Product Change Information

Product Name	Part Number
Application	SiC Power module TO220 2L type & 3L type	SCS110AGC/SCS205KGC SCS208AGC/SCS210AGC SCS220AGC/SCS220KGC SCS220KGHRC/SCT2120AFCU
Detailed description of change	Current Tube type : Stopper pin hole position is different between 2L and 3L type	Subsequent Tube type : Stopper pin hole position is common between 2L and 3L type
Anticipated impact on quality	There are no impact on fit, function, reliability and Electrical characteristics. "Stopper pin" (inserted into "Stopper pin hole") is to prevent products from coming off from tube. We assume this hole is not used in the process at customer side.	
Purpose of Change	To stabilize supply by integrating to single tube type	
Time of change	Running change	
Qualification samples	from Feb/2016

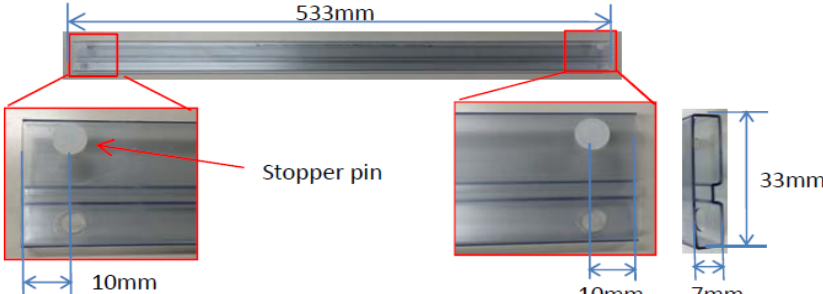
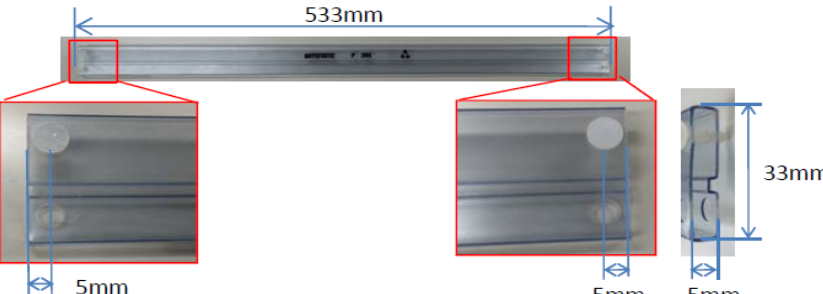
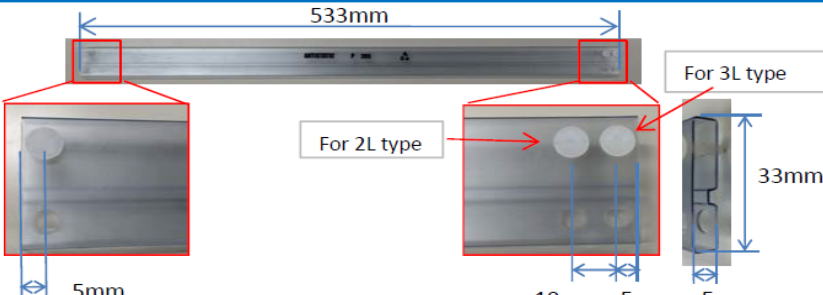
Current/ Subsequent	Type	Picture and dimension	Material	Stopper pin hole
Current	2L type	 <p>533mm</p> <p>10mm</p> <p>10mm</p> <p>7mm</p> <p>33mm</p> <p>Stopper pin</p>	PVC +Antistatic Treated	Left side : 1 place Right side : 1 place
	3L type	 <p>533mm</p> <p>5mm</p> <p>5mm</p> <p>5mm</p> <p>33mm</p>	PVC +Antistatic Treated	Left side : 1 place Right side : 1 place
Subsequent	2L/3L	 <p>533mm</p> <p>5mm</p> <p>10mm</p> <p>5mm</p> <p>5mm</p> <p>33mm</p> <p>For 2L type</p> <p>For 3L type</p>	PVC +Antistatic Treated	Left side : 1 place Right side : 2 places

Dimension and material is same. Subsequent 2L/3L type has two stopper pin hole at right side.
